Lower Thames Crossing TR010032

Deadline 9 Submission

Thames Crossing Action Group Unique Reference: 20035660

DEADLINE 9 (11th December 2023) / Submitted 11th December

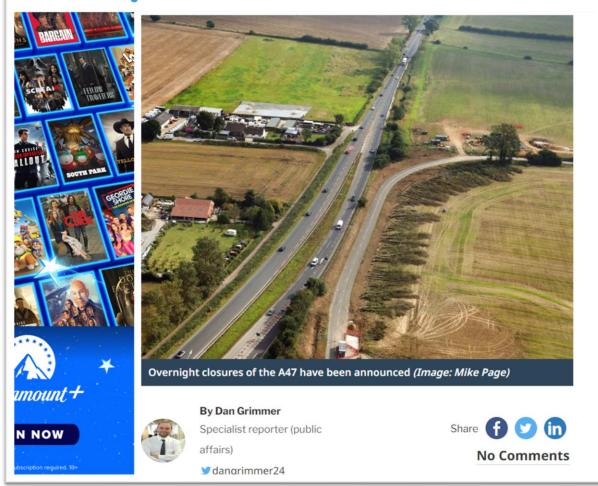
6. Further to our previous comments at D8 [REP8-191] from paragraph 145, and having now had the opportunity to read the previously mentioned changes to requirement 27 (below), we remain concerned and opposed to such wording.

- 7. We do not agree that any Compulsory Acquisition (CA) or any works should be allowed to begin until such time as any legal challenge have concluded, regardless of how long that is after the order has been made, if it is made.
- 8. The right to legally challenge should not be inhibited in any way. Firstly, as people should have a right to legally challenge the decision, and secondly because irreversible harm can be carried out if such actions take place prior to legal challenges concluding.
- For example, we know there has been irreversible harm from NH actions in regard to the A47, which as you know still has an outstanding legal challenge against it. Photographic evidence can be clearly viewed in media coverage¹ of more than a dozen trees cut down. (Captured and pasted below)
